2.2 Control and Instrument Systems

The information in this section of the reference ABWR DCD, including all subsections, tables, and figures, is incorporated by reference with the following departures.

Figure 2.2.1 Rod Control and Information System Control Interface Diagram

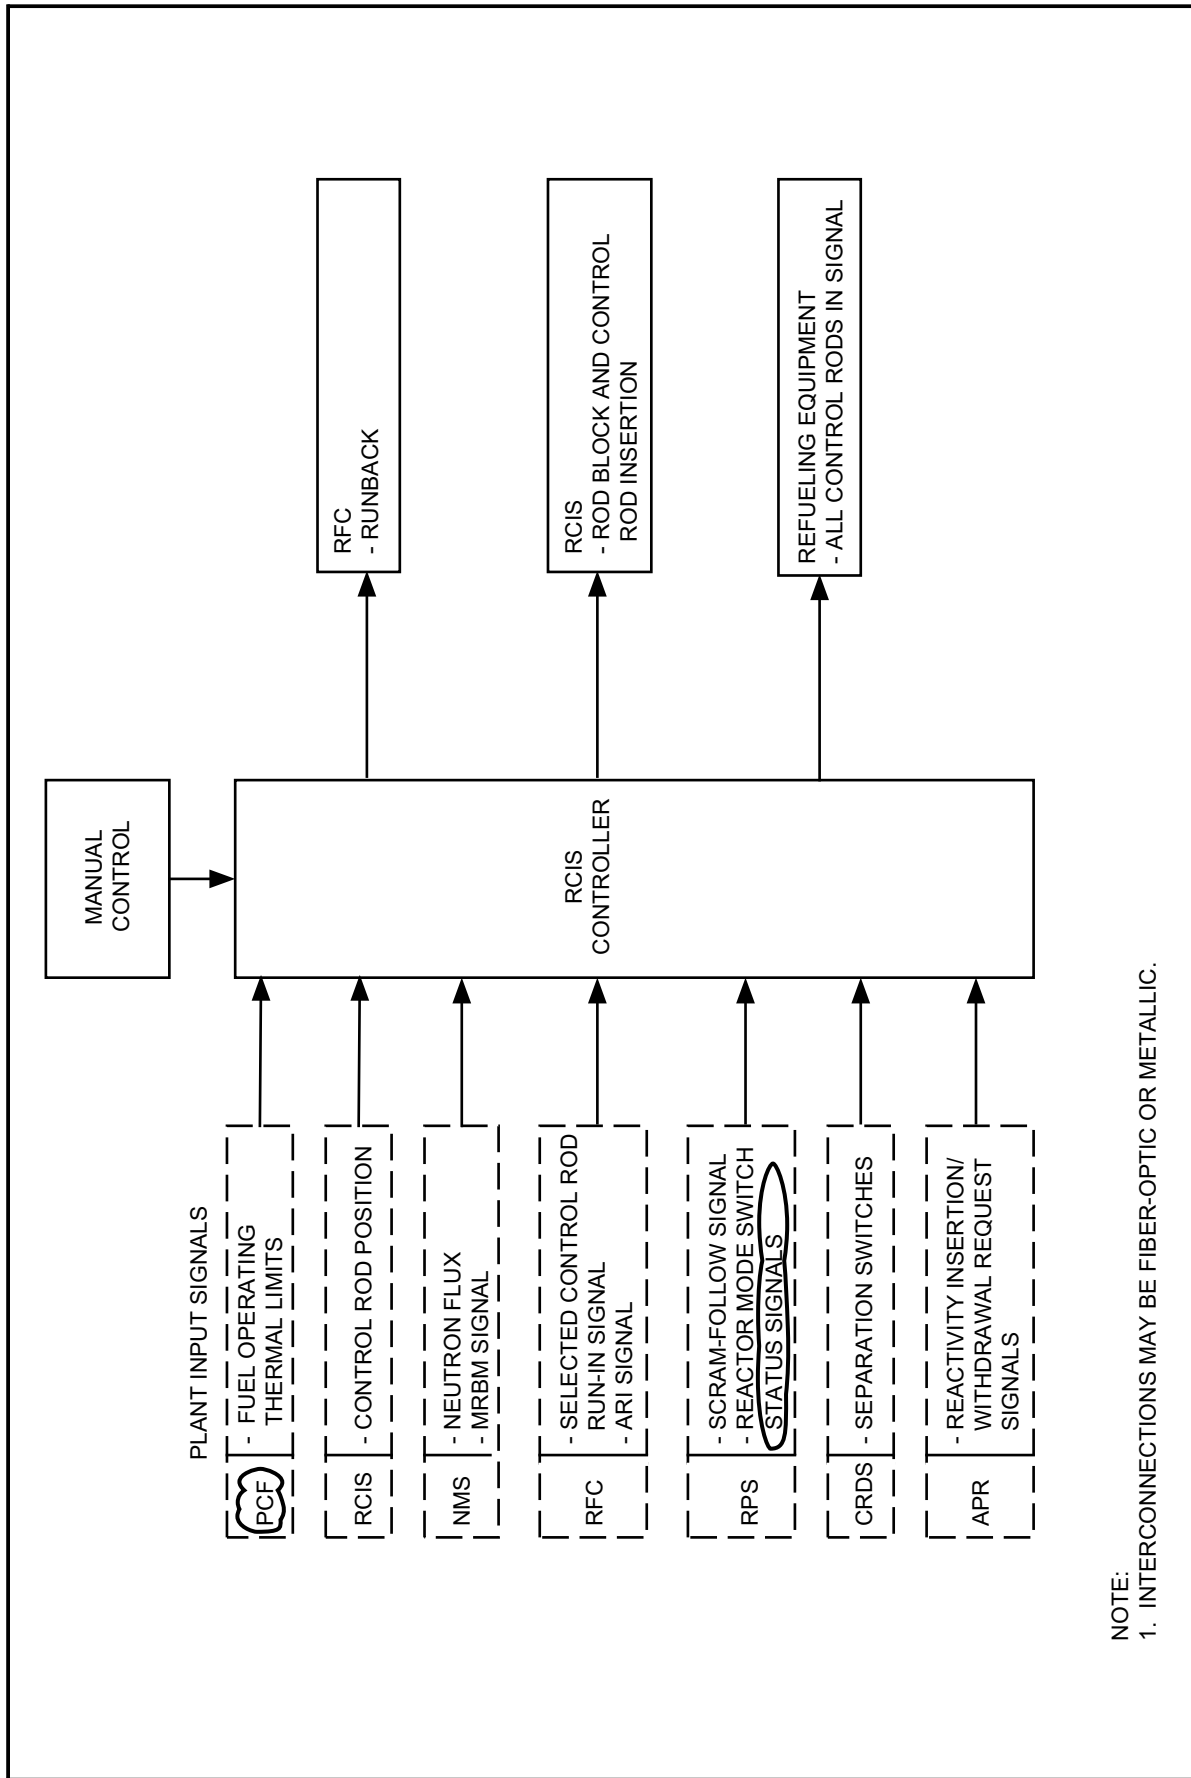
STD DEP T1 2.2-2 (Figure 2.2.1—RPS, Table 2.2-1—Item 8)

STD DEP T1 3.4-1 (Figure 2.2.1—PCF)

(b) *A signal from the CRD System FMCRD hollow piston/ball nut separation switches (withdrawal block applies only to separated control rod if the associated control rod is selected for movement when the RPS Mode Switch is in the Startup Mode or Run Mode), or*

Figure 2.2.5 Neutron Monitoring System

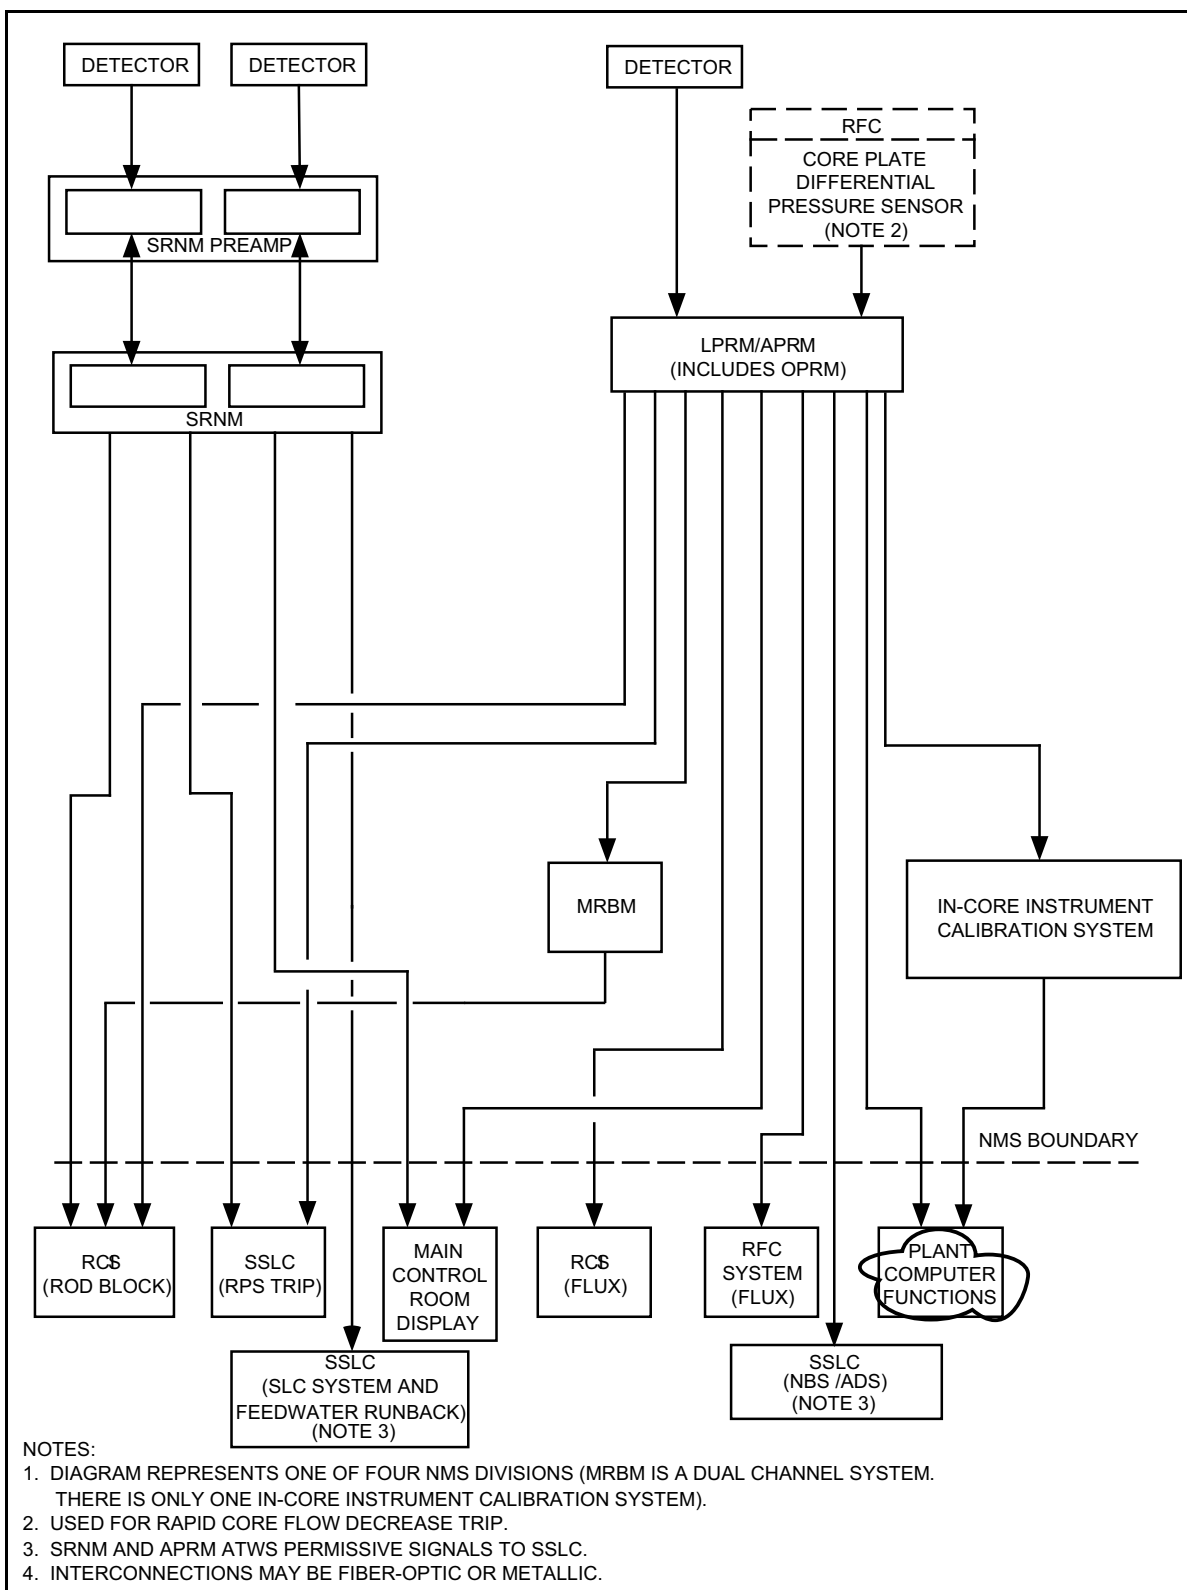
STD DEP 3.4-1 (Figure 2.2.5)

The automated in-core instrument calibration system provides local power information at various core locations that correspond to LPRM locations. The automated in-core instrument calibration system uses its own set of in-core detectors for local power measurement and provides local power information for three-dimension core power determination and for the calibration of the LPRMs. The measured data are sent to the ~~Process Computer System~~ Plant Computer Functions for such calculation and LPRM calibration.

Figure 2.2.7a Reactor Protection System Control Interface Diagram

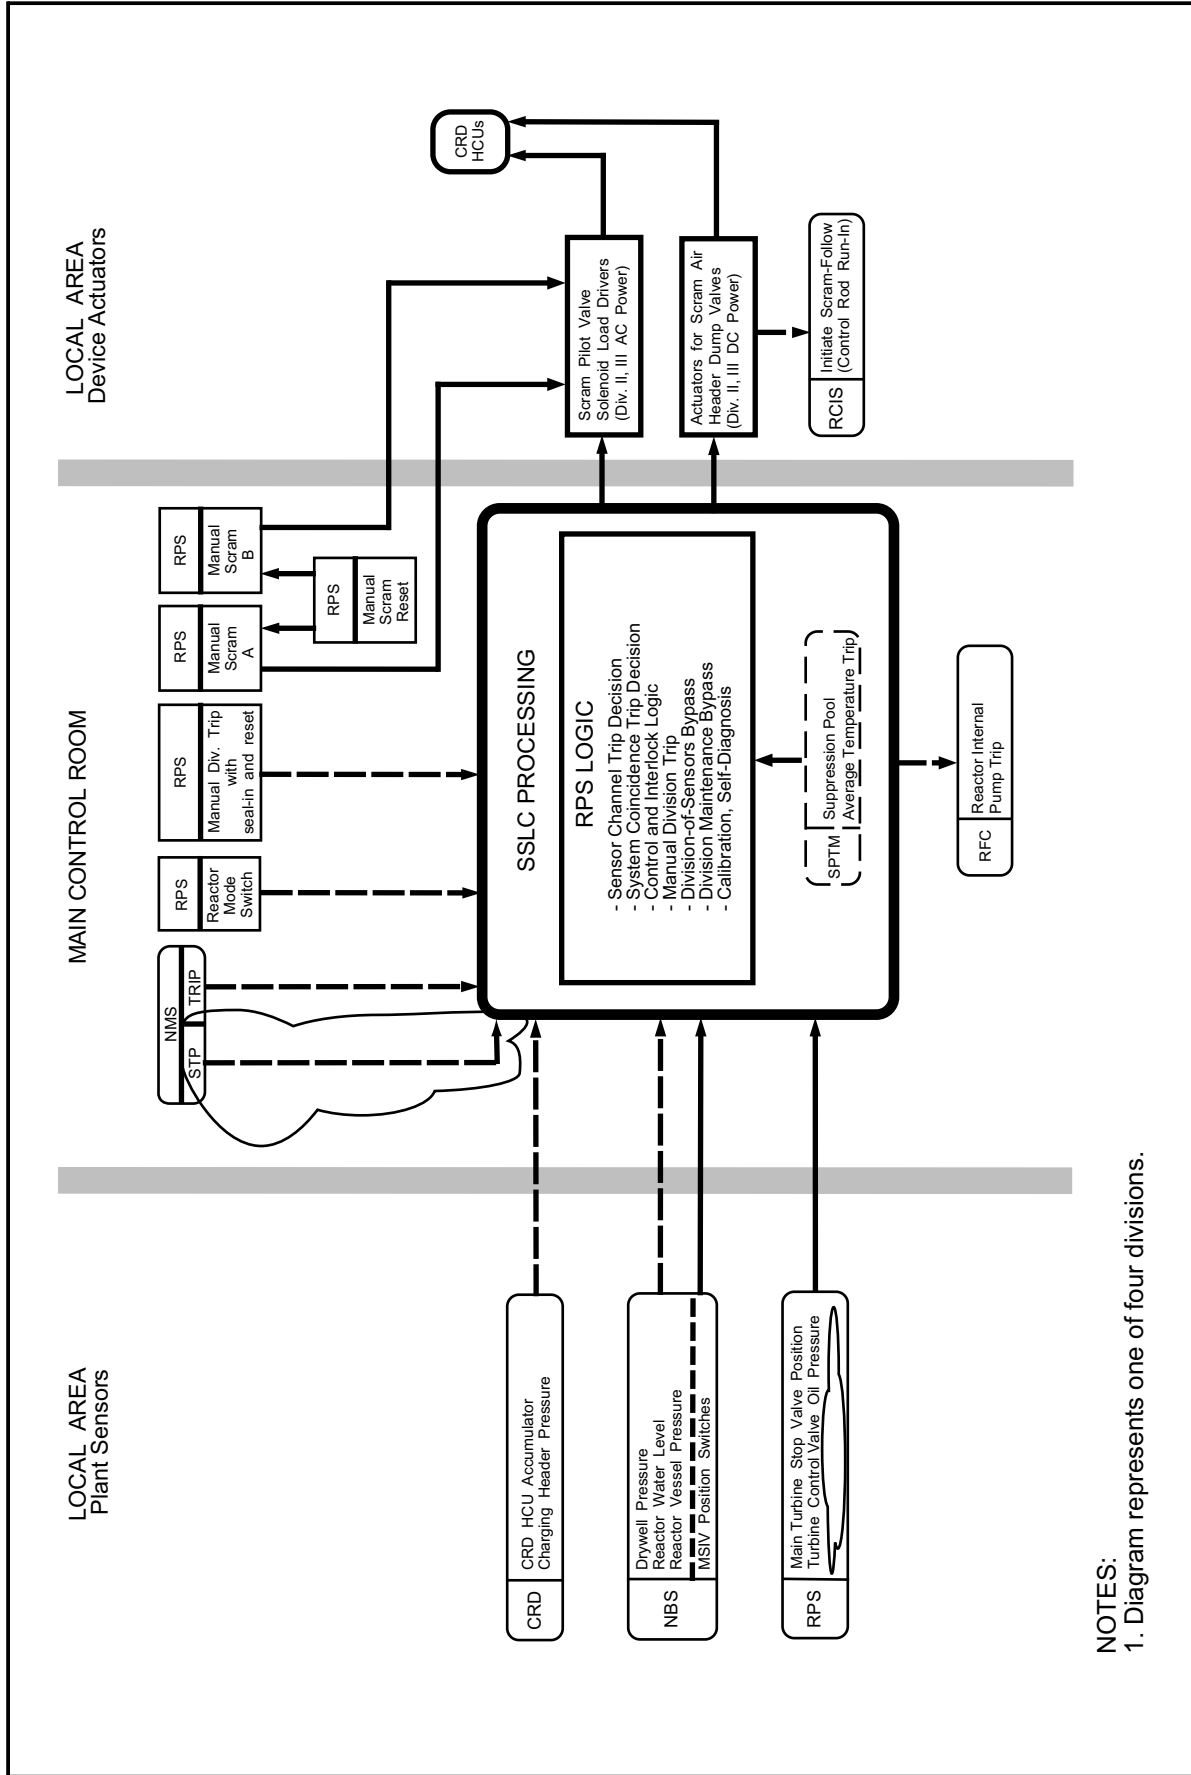
STD DEP T1 2.2-1 (Figure 2.2.7a, Table 2.2.7)

As shown in Figure 2.2.7a, the RPS interfaces with the Neutron Monitoring System (NMS), Nuclear Boiler System (NBS), Control Rod Drive (CRD) System, Rod Control and Information System (RCIS), Recirculation Flow Control (RFC) System, and the Suppression Pool Temperature Monitoring System (SPTM)., and the Essential Multiplexing System (EMS). Figure 2.2.7a also depicts the primary implementation of RPS logic within the Safety System Logic and Control (SSLC).

As shown on Figure 2.2.7a, the RPS has manual divisional trip switches, reactor mode switch, manual scram switches, and scram reset switches for manual controls. Divisional trip displays, and scram solenoids electrical power status lights are also provided. These RPS controls and displays are provided in the main control room. Fail safe RPS sensors are turbine control valve oil pressure ~~switches,~~ sensors and turbine stop valve position switches, ~~and turbine first stage pressure sensors.~~ These sensors are located in the Turbine Building.

Figure 2.2.7b Reactor Protection System

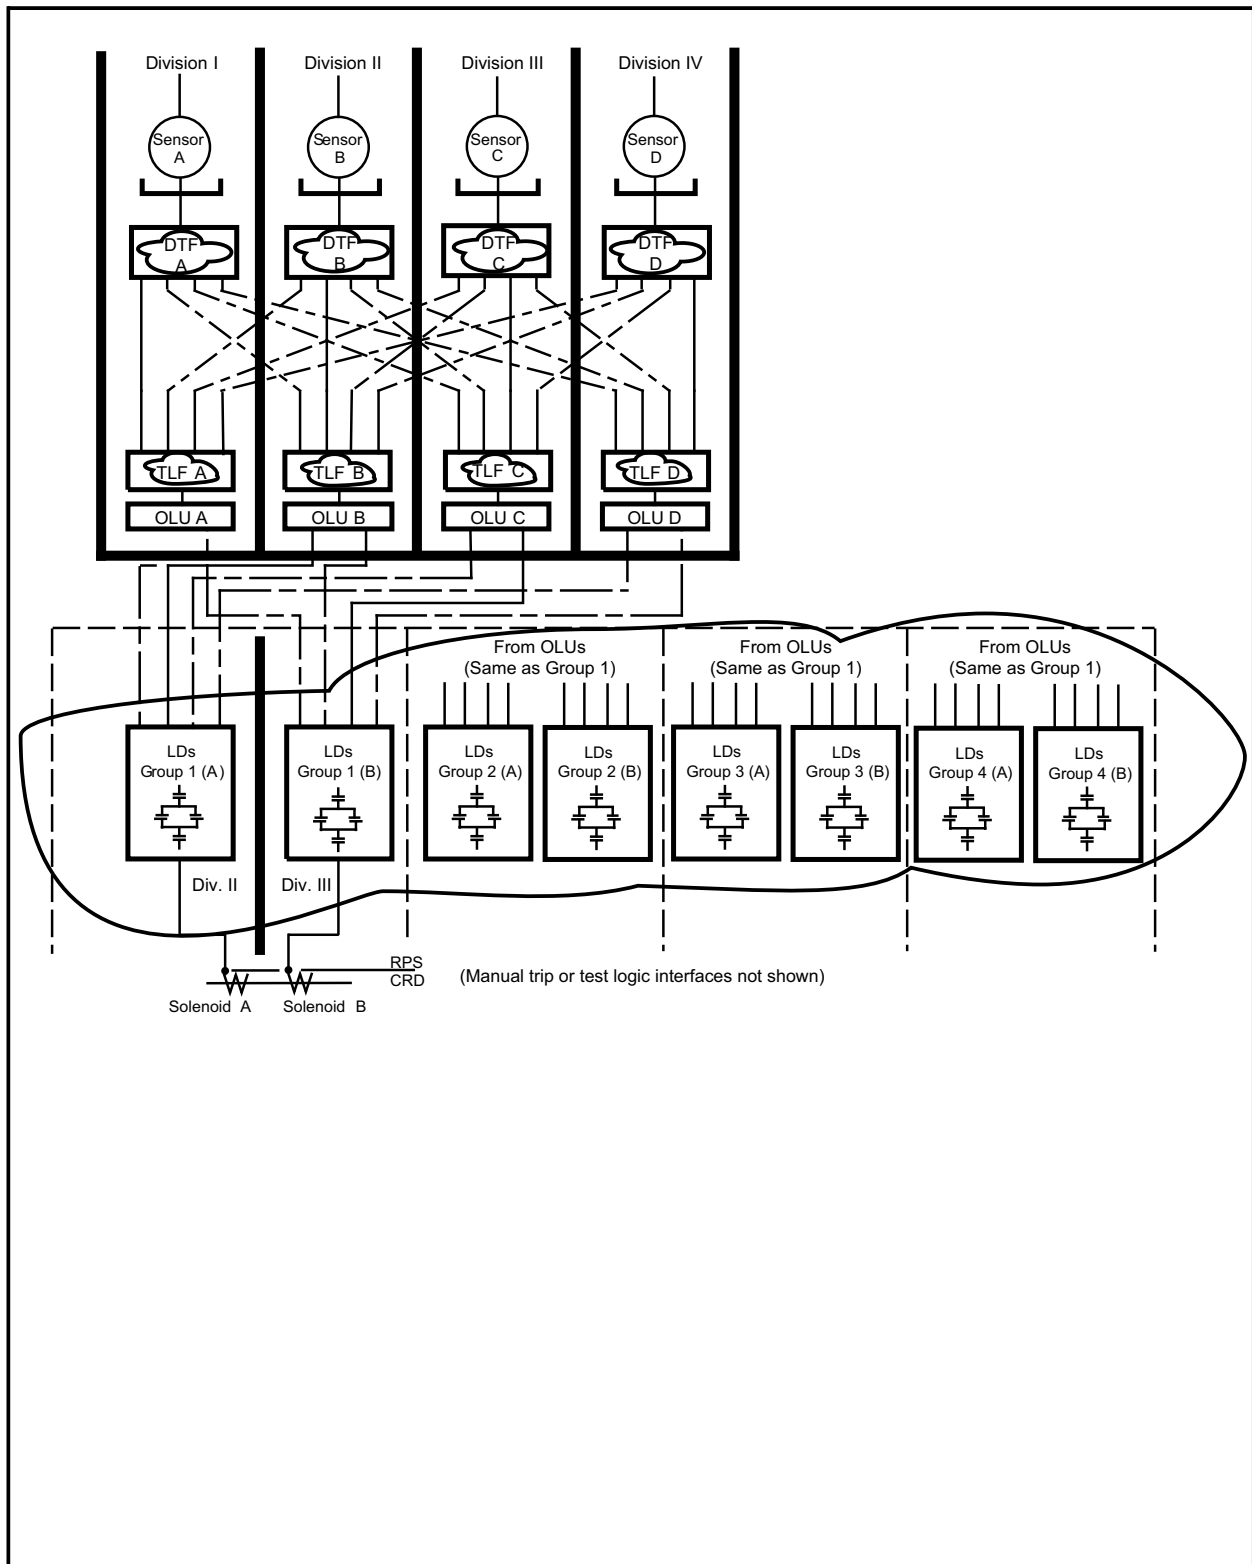
STD DEP T1 3.4-1 (Figure 2.2.7b)

The RPS has four divisions. Figure 2.2.7b shows the RPS divisional aspects and the signal flow paths from sensors to scram pilot valve solenoids. Functions Equipment within an RPS division consists of include sensors (transducers or switches), multiplexers, data communication, digital trip modules functions (DTM DTF), trip logic unit function (TLU TLF), output logic unit (OLU), and load drivers (LD). The LDs are only in Divisions II and III. The (DTF) and (TLF) are performed in digital control processors. The data communication functions are described in Section 2.7.5.

The RPS consists of logic and circuitry for initiation of both automatic and manual scrams. The automatic scram function is comprised of accomplished redundantly in four independent divisions of sensor instrument channels, hardware/software based logic and logic processing, and two independent divisions of actuating devices. Automatic scram is initiated whenever a scram condition is detected by two or more automatic divisions of RPS logic. For automatic-scram, the sensor input signals to the RPS originate either from the RPS's own sensors or other systems' sensors. For determination of the existence of an automatic scram condition, within each automatic-scram-channel division of the RPS, the DTM DTF of a given RPS channel division compares the monitored process variable with the a stored setpoint stored in its memory and issues a trip signal if the monitored process variable exceeds the setpoint. The DTM DTF then sends the trip signal to the TLU TLF of its own channel division and the TLU TLFs of the other three channels divisions of RPS, where two-out-of-four voting is performed (see Figure 2.2.7b). The TLF in each division performs an independent two-out-of-four vote on each RPS DTF input.
